THE SHERWIN-WILLIAMS COMPANY
Environmental, Health & Regulatory Services
101 Prospect Avenue NW
Cleveland, Ohio 44115-1075
Facsimile: (216) 566-2730

February 10, 2010

RE: United States Avenue Burn Site
Gibbsboro, New Jersey
Administrative Order Index No. II CERCLA-02-99-2035
Response to EPA and NJDEP Comments on:
“Groundwater Results Evaluation and Proposal for Further Action”,
dated August 18, 2009

Northern Burn Site Area (White Sand Branch) - Horizontal hydraulic gradient and range of seepage velocities calculated using individual K values for BSMW0001, BSMW0004 and the site geometric mean calculated using the Bouwer & Rice method (Table 4)

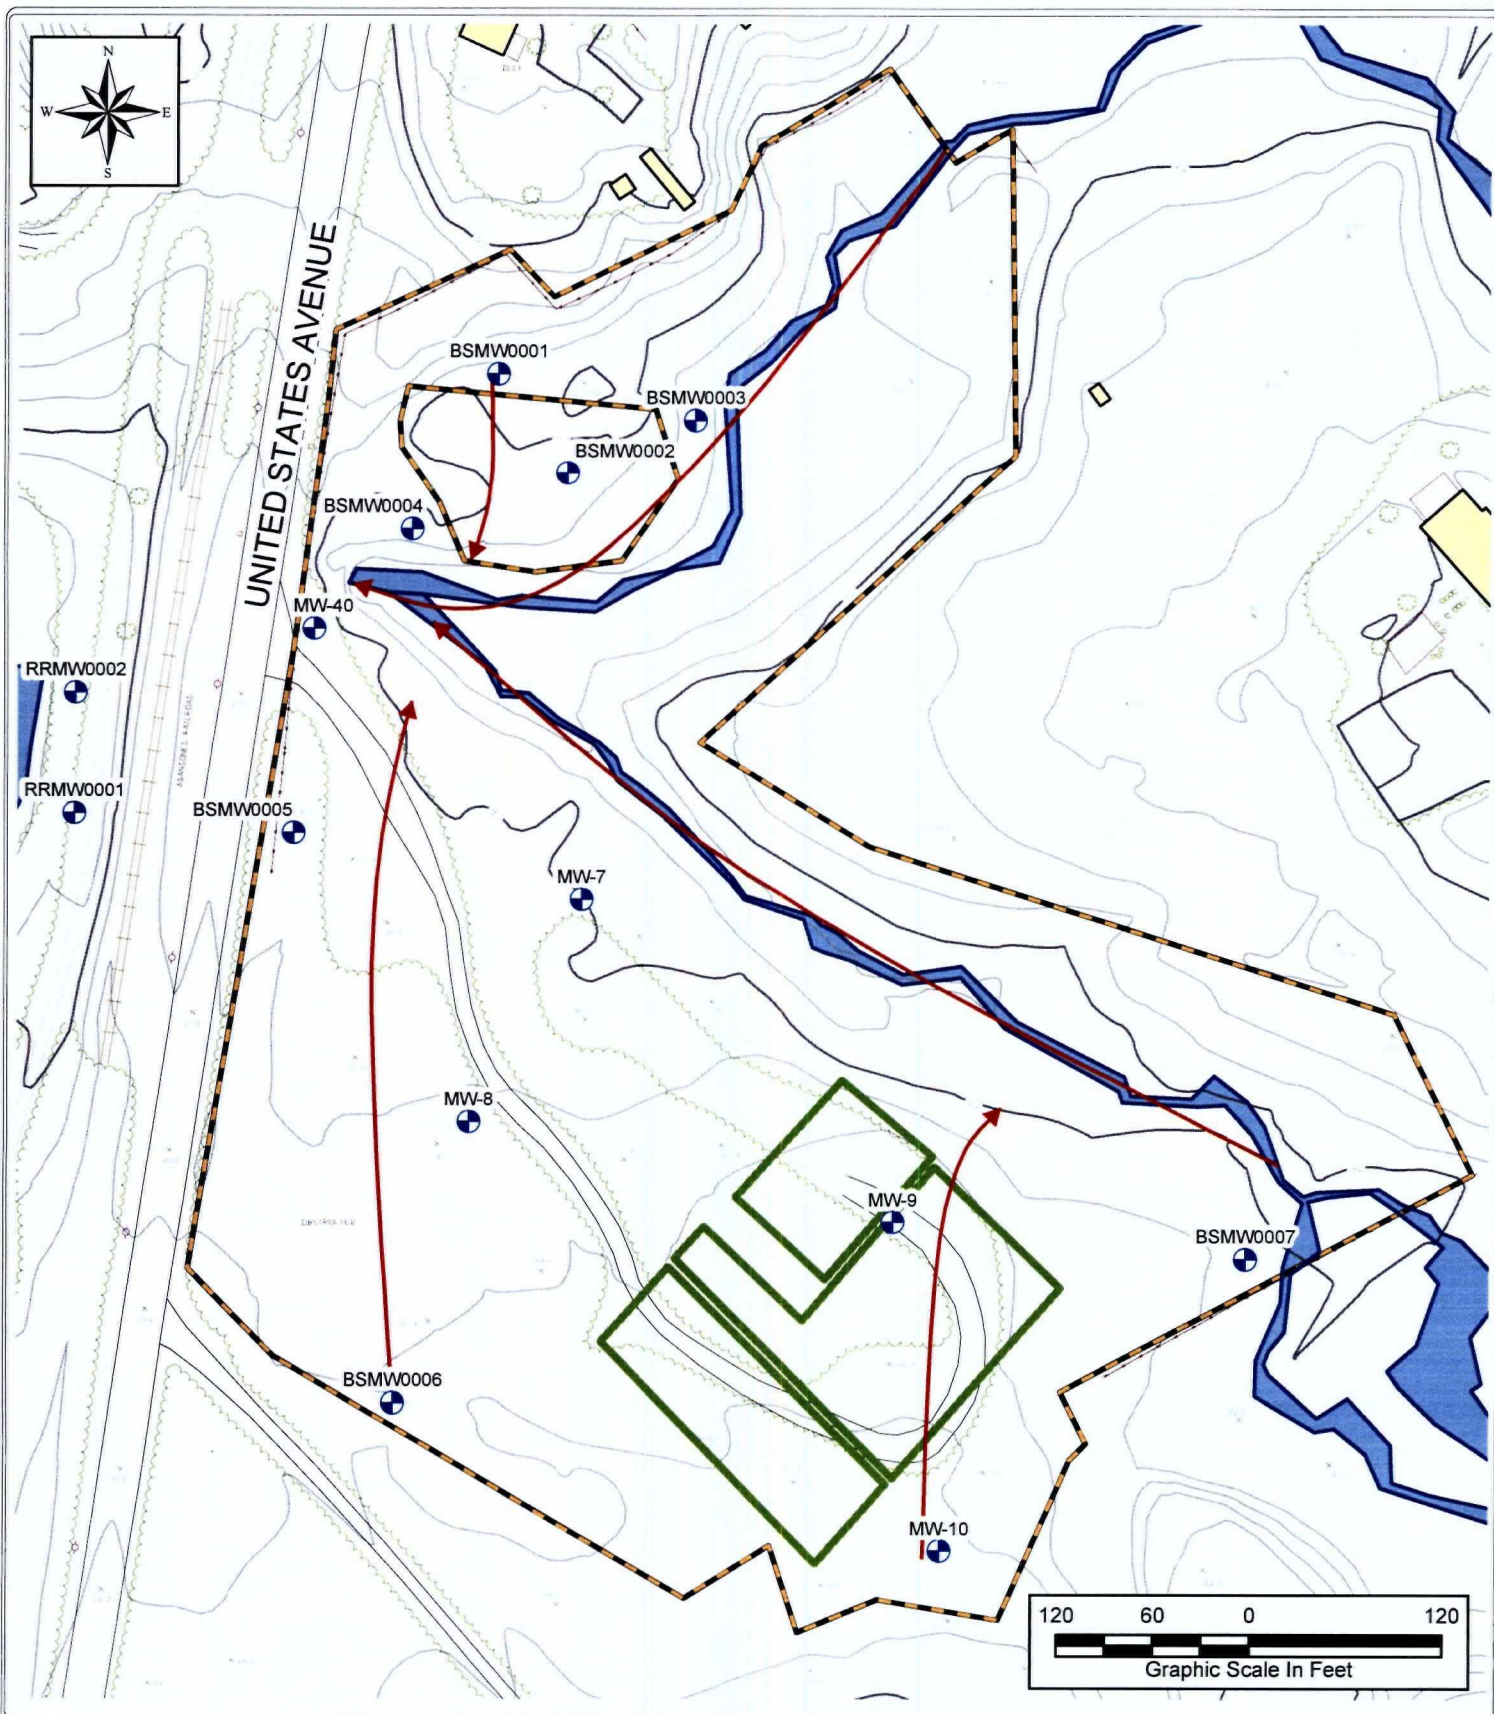
General Comment 3. *The best map to illustrate the conceptual hydrogeology model is the small inset map (figure) shown on Table 5. EPA is requesting that this figure be enlarged and would recommend that it be used to prepare a section on the site conceptual model and transport pathways. The transport of contaminated water is likely occurring via surface water and base-flow in the aquifer as it passes under the railroad tracks.*

Response: A larger version of this map has been included with this response and is referenced as Table 5 – Figure 1 in the revised text. Once the proposed additional wells are installed, developed, sampled and their hydraulic characteristics calculated, additional evaluation regarding the conceptual site model and contaminant transport pathways will be presented to EPA.
